SUBDIVISION REPORT - CONCEPT/SPECIAL USE

▶ **FILE #:** 2-SB-23-C **AGENDA ITEM #:** 17
2-C-23-SU **AGENDA DATE:** 4/13/2023

▶ **SUBDIVISION:** BUFFAT MILL ESTATES

▶ **PROPOSED USE:** Residential subdivision for duplexes

ROAD PROFILES

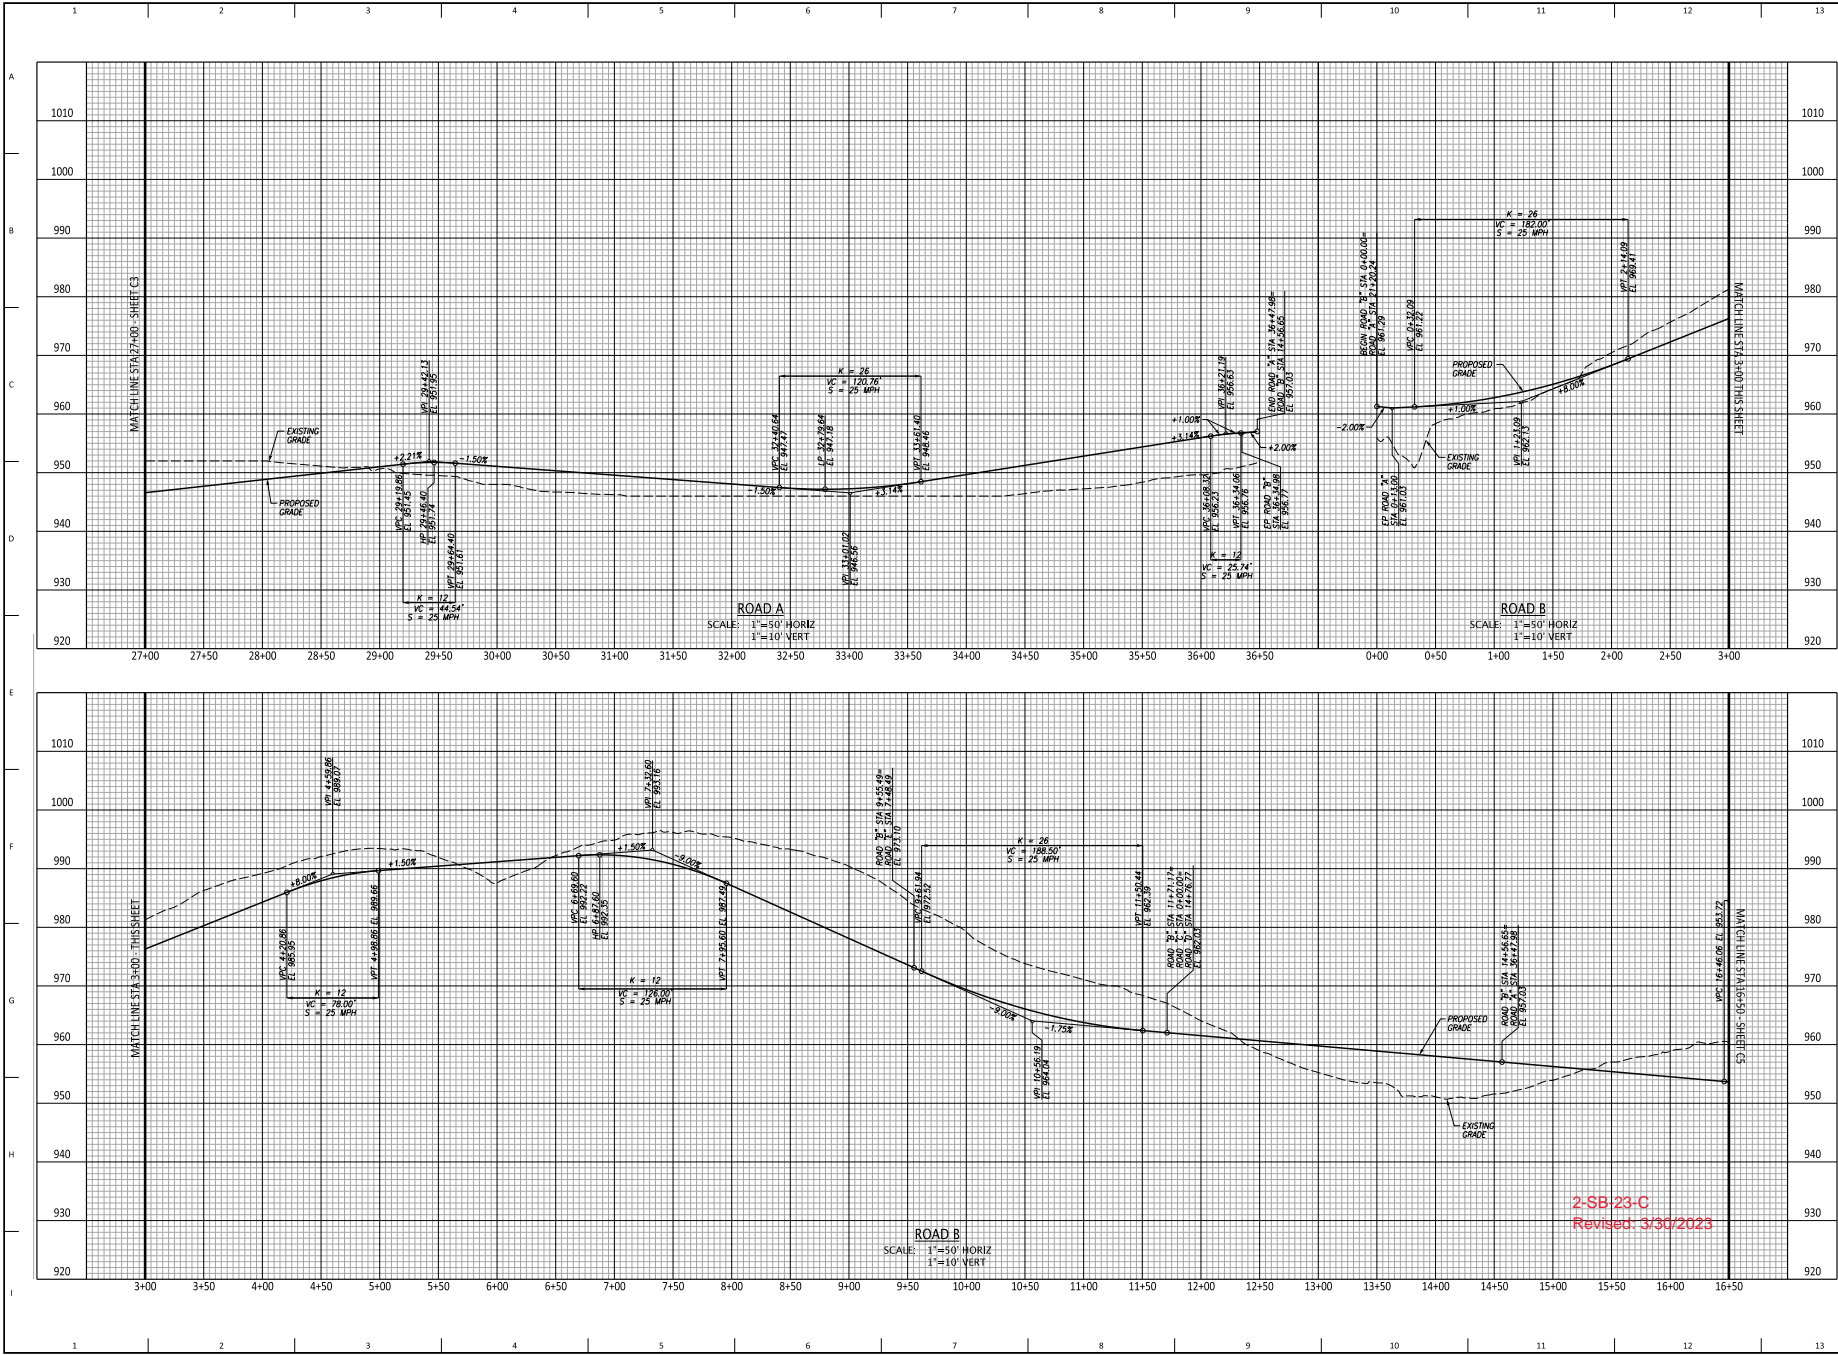
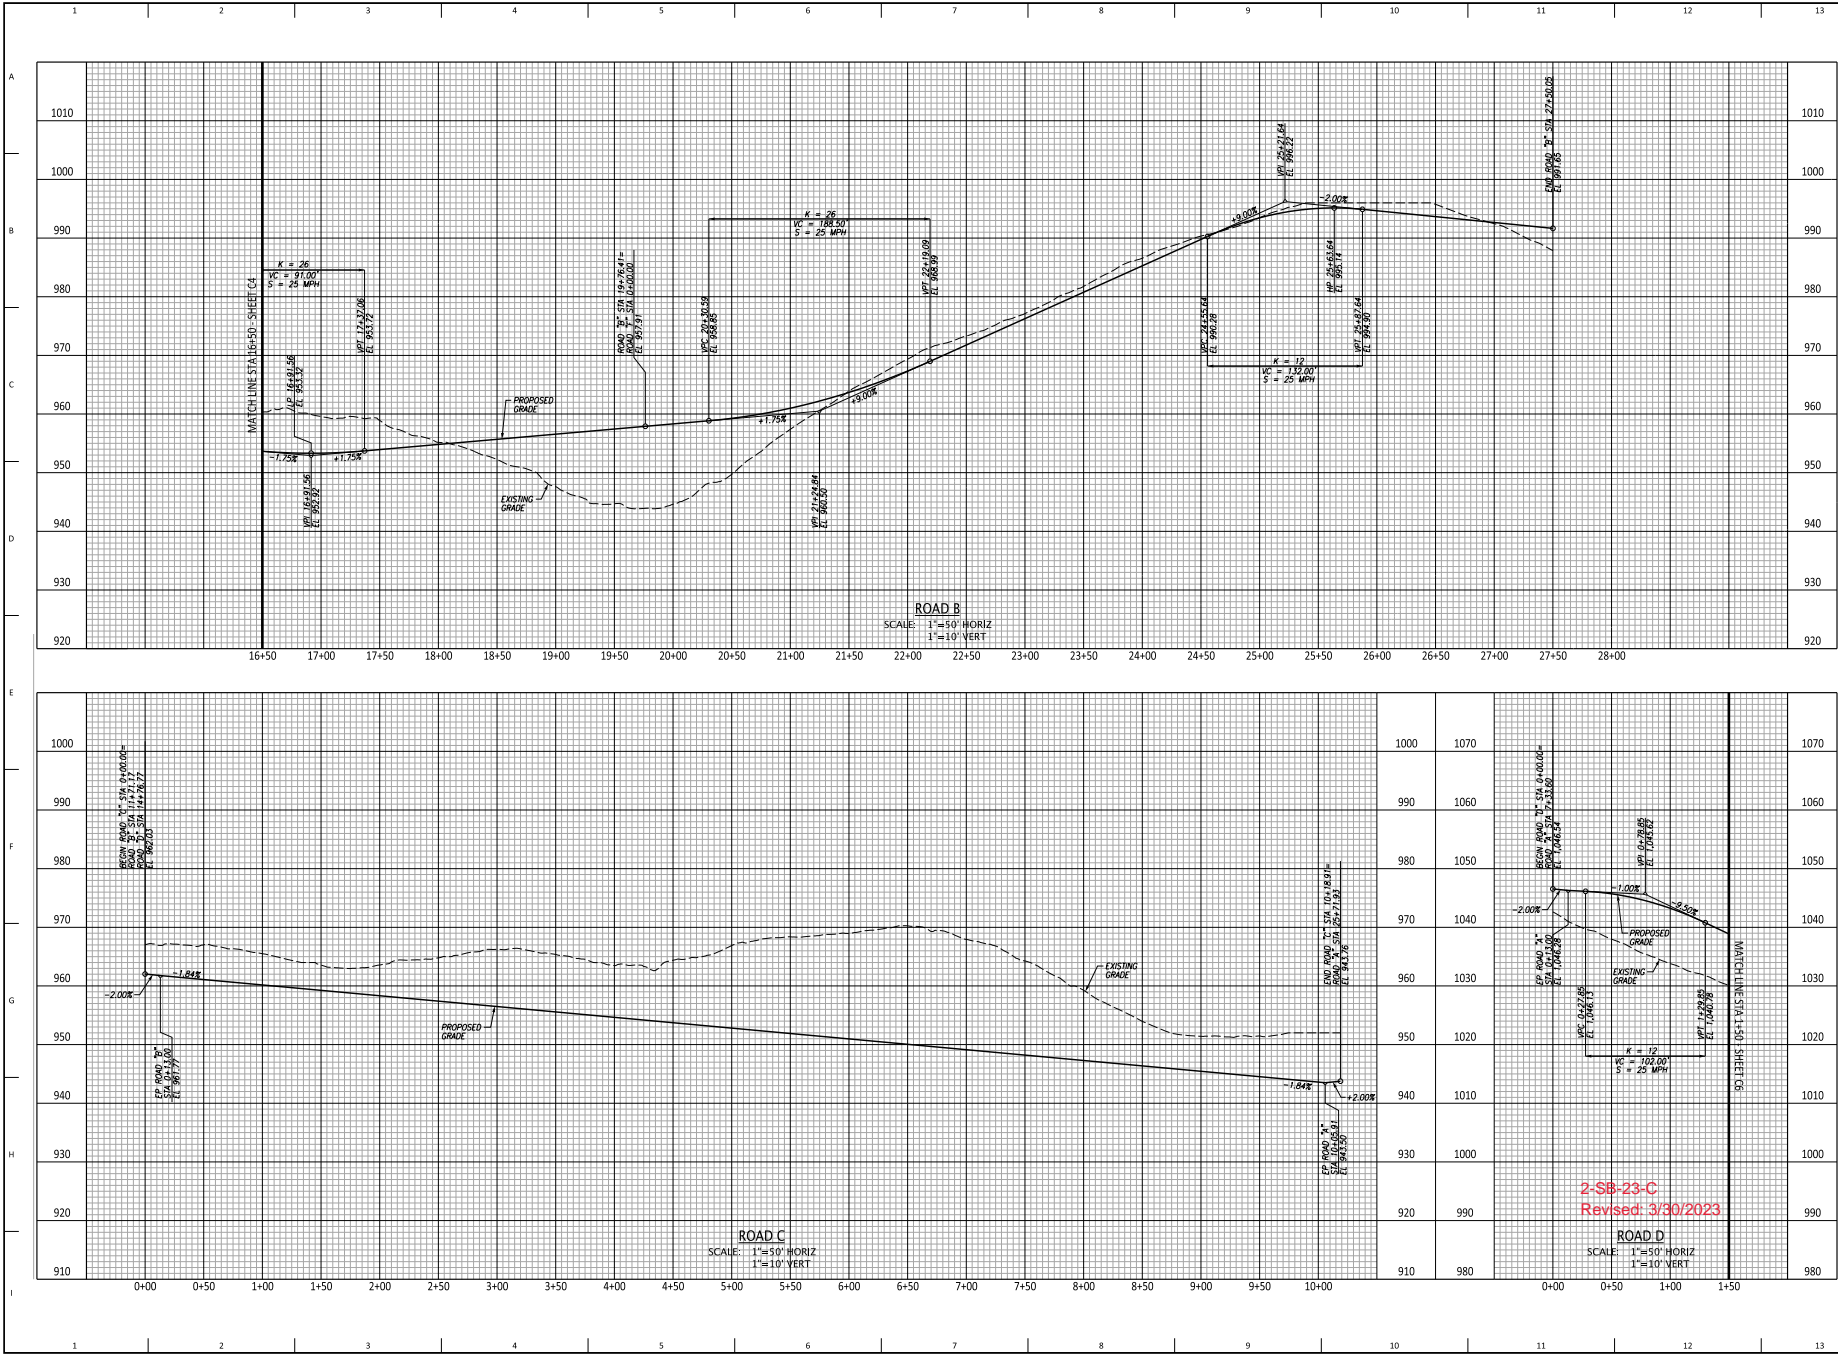
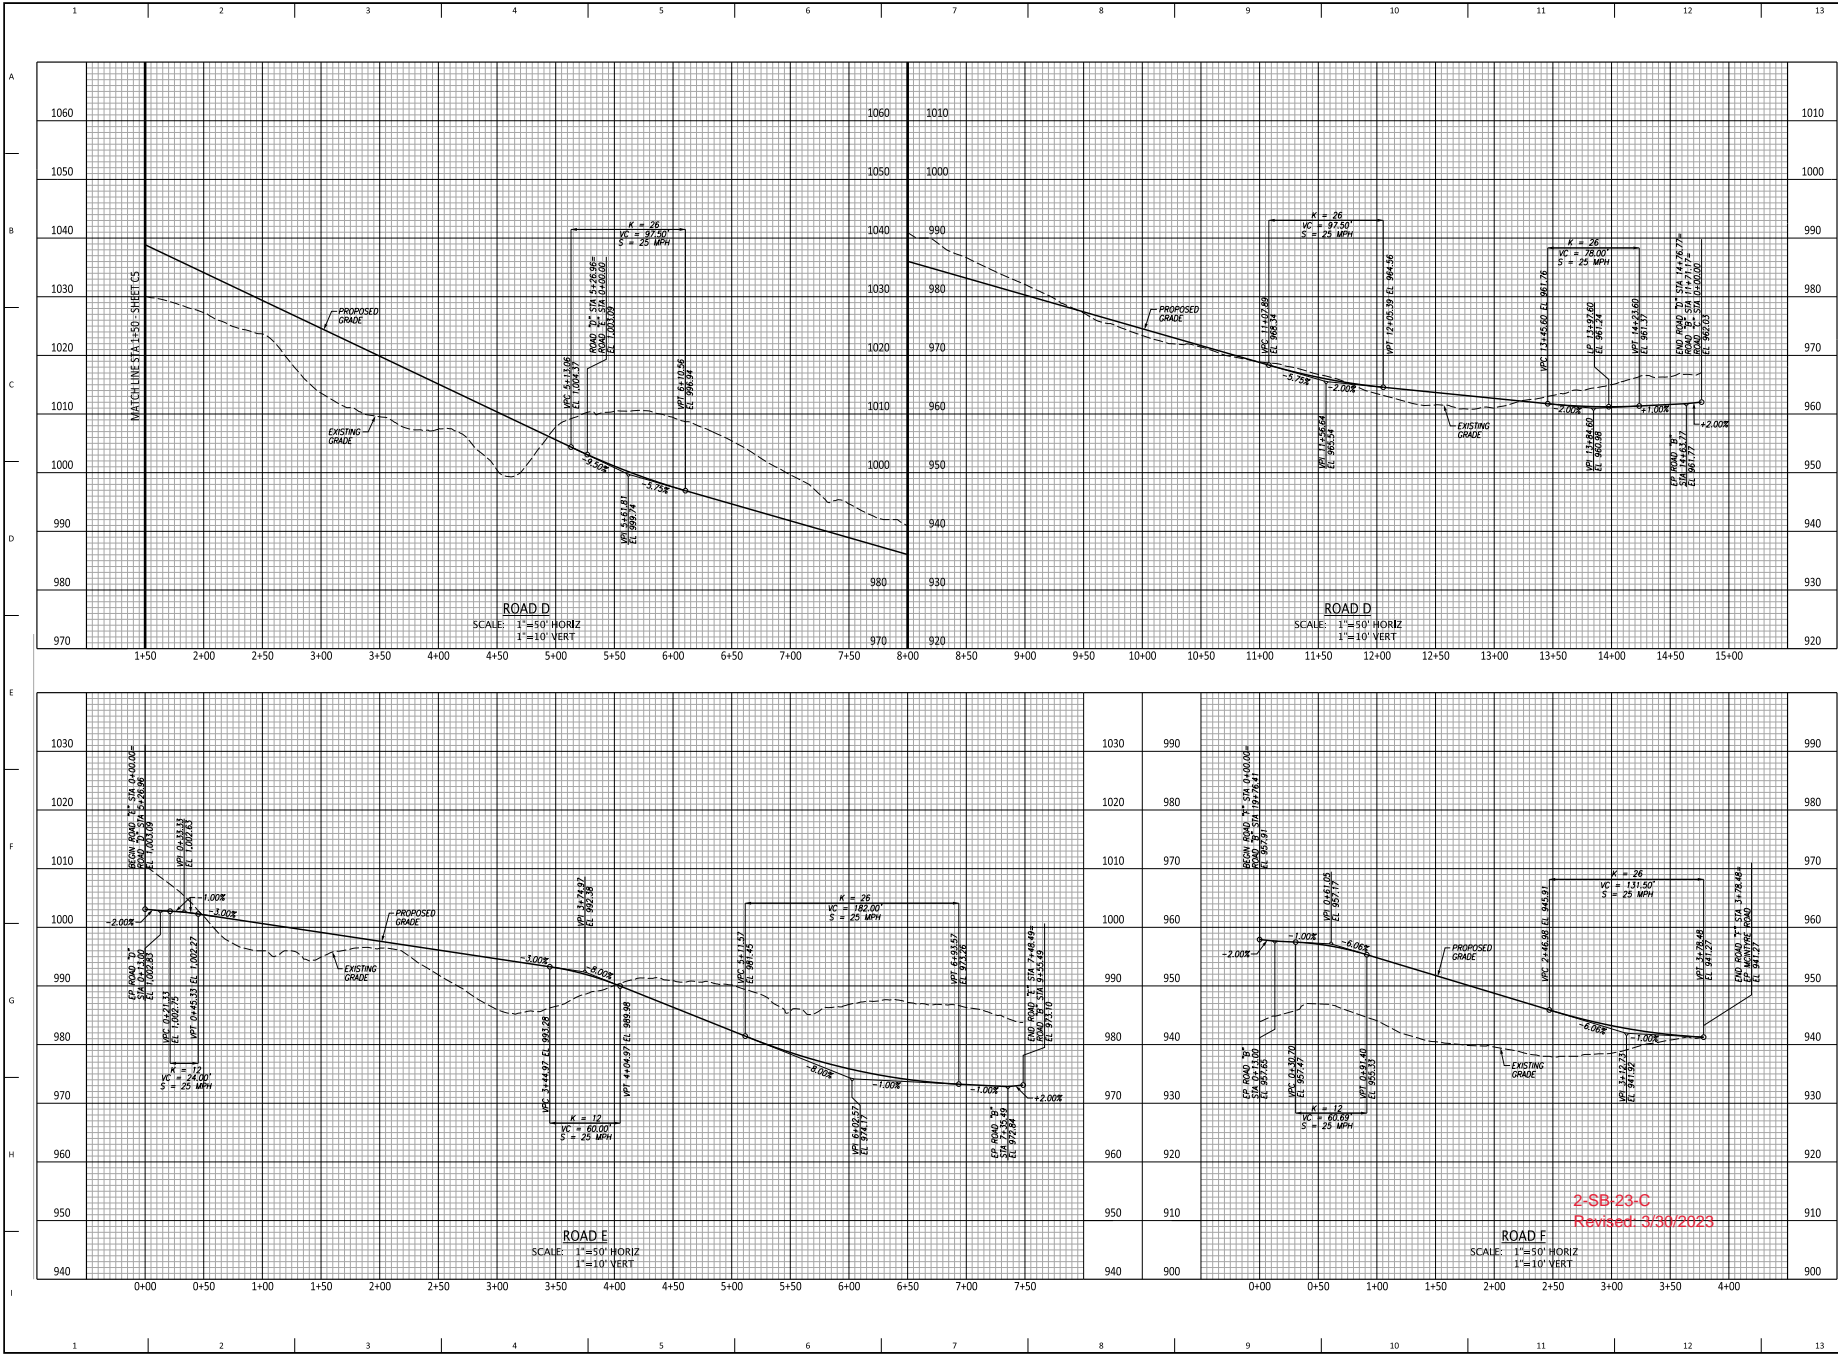
1. Increase the maximum road grade from 12 percent to 13 percent on Road 'A' between STA 3+07.27 and 7+90.27

1. Increase the maximum road grade from 12 percent to 13 percent on Road 'A' between STA 3+07.27 and 7+90.27

1. Increase the maximum intersection grade from 1 to 1.84 percent on Road 'C' at the Road 'A' and Road 'B' intersections.

The City of Knoxville recommends consideration of these variances.

Buffat Mill Road at Roadway Connection (Road "A")
Intersection Sight Triangles

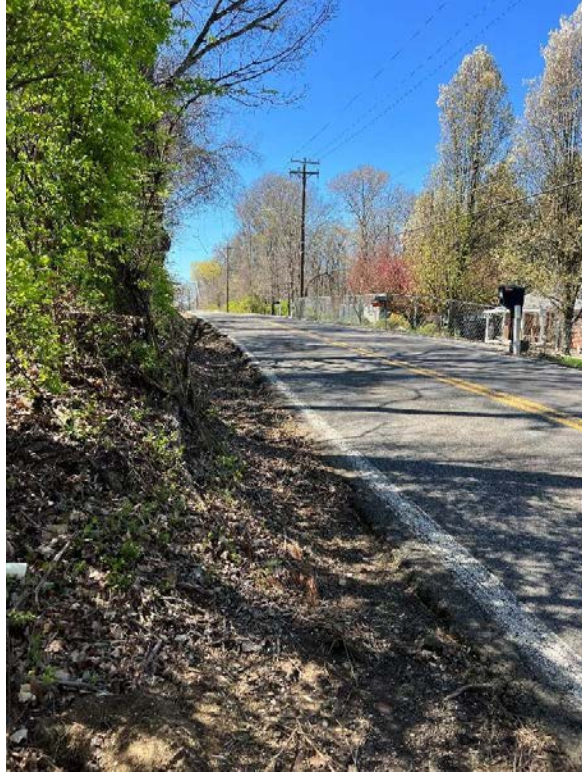
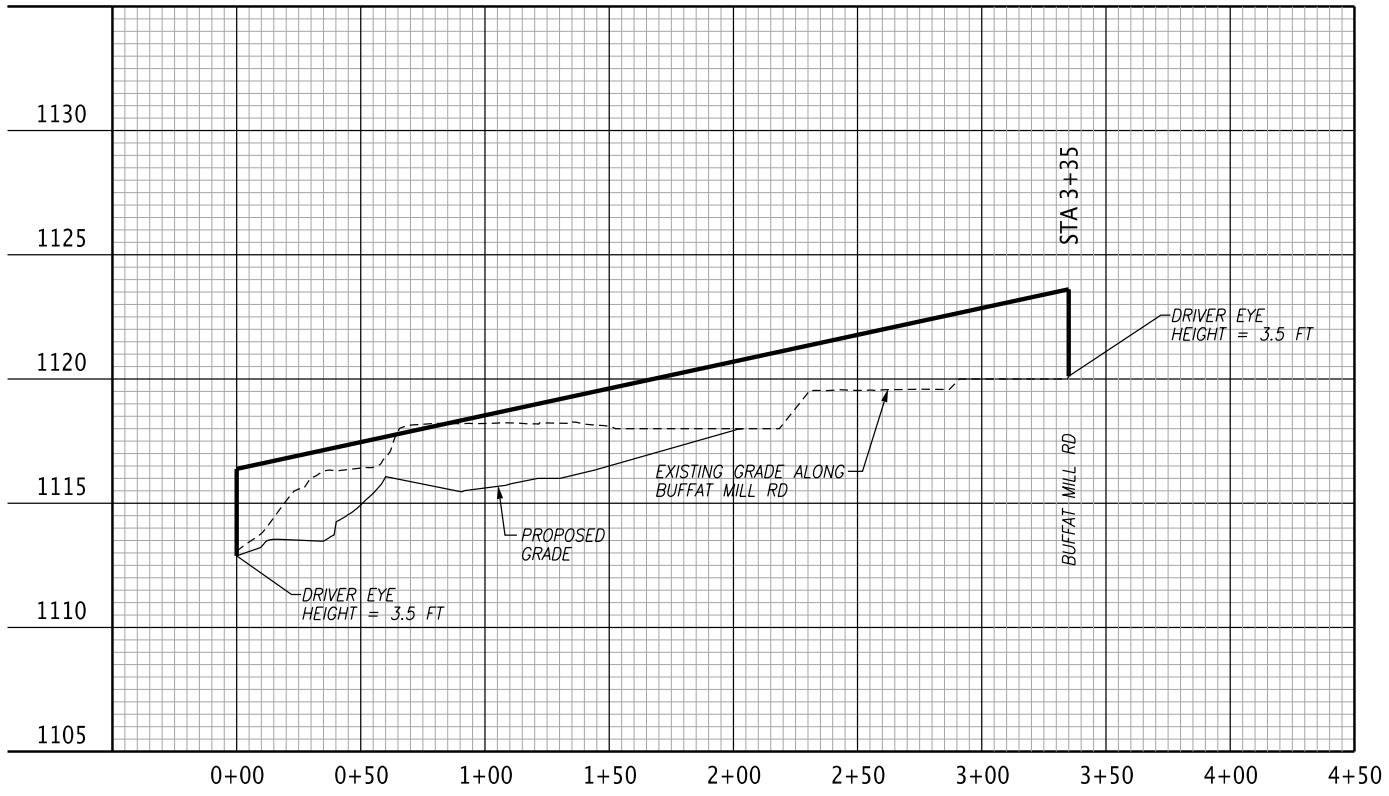
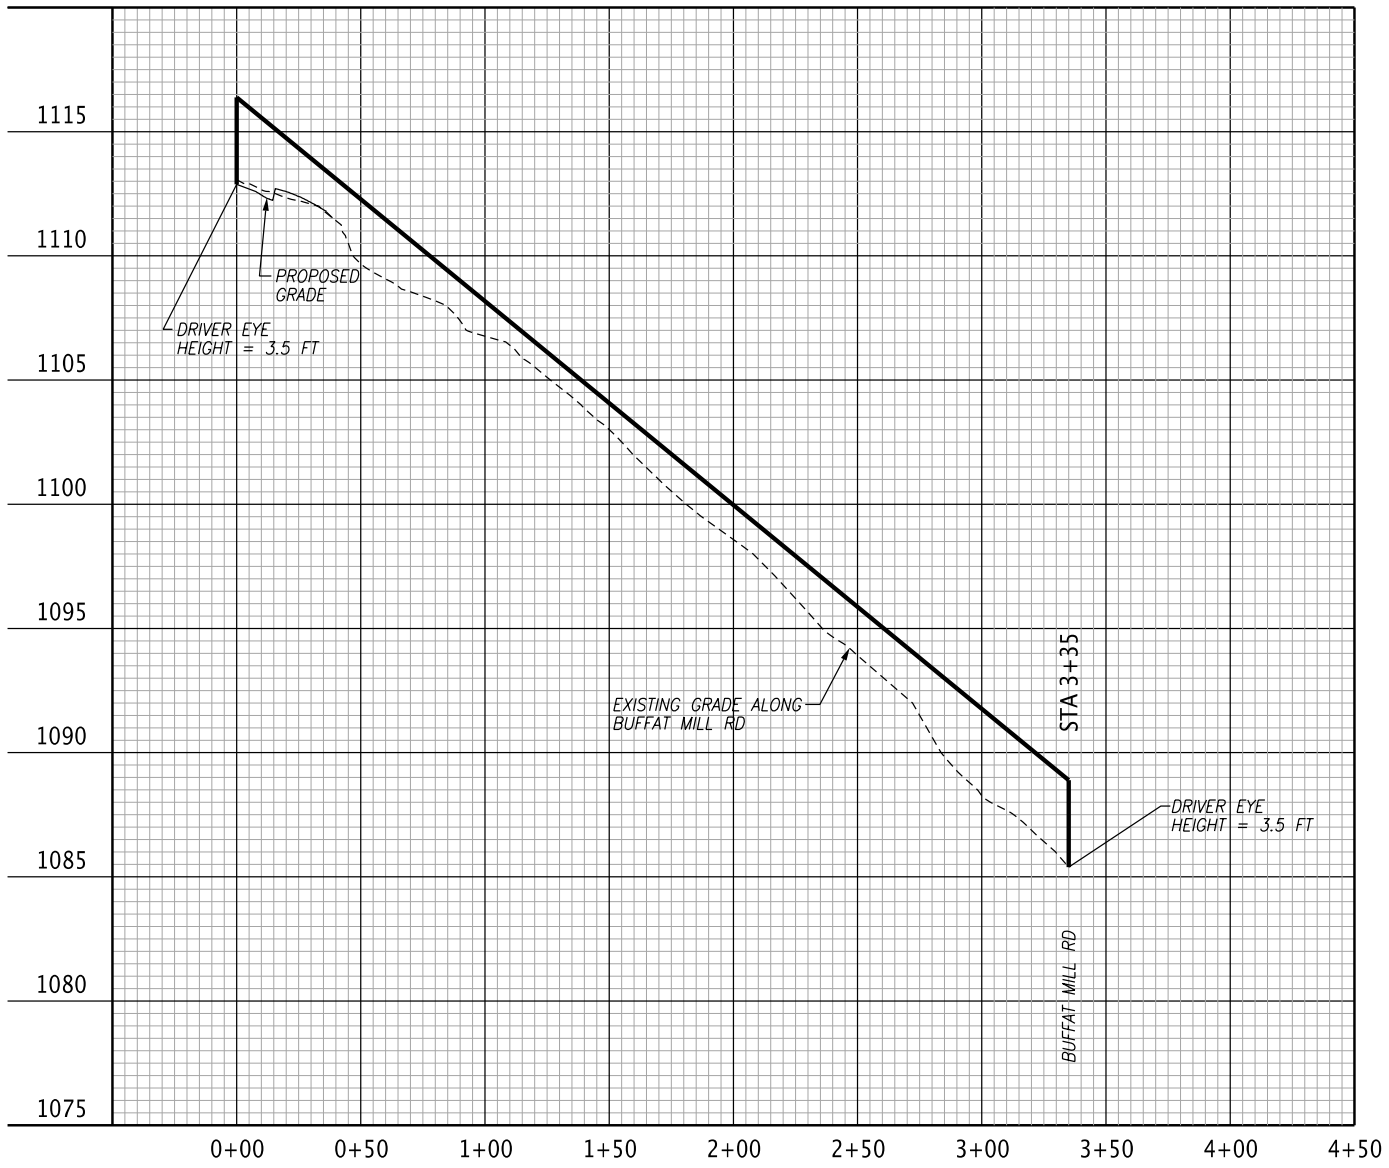
4. Certifying that the required sight distance in both directions is available at the intersections of Buffat Mill Rd, McIntyre Rd, and, if required during the design plan phase, the interior intersections. Documentation shall be provided to and approved by the Knoxville Department of Engineering during the design plan phase.

Ardurra recommends that the intersection sight distance be certified by a land surveyor prior to construction in order to verify that Buffat Mill Road has adequate intersection sight distance at the proposed roadway connection (Road "A") to comply with City of Knoxville and AASHTO requirements. No sight distance easement will be needed.

The intersection sight triangles at the intersection of Buffat Mill Road at the Roadway Connection (Road "A") do not show that any easements will be required from the adjoining properties. Any required sight distance easements for the internal subdivision intersections should be coordinated with the City of Knoxville Department of Engineering and included on the final design drawings prior to construction of the residential development.
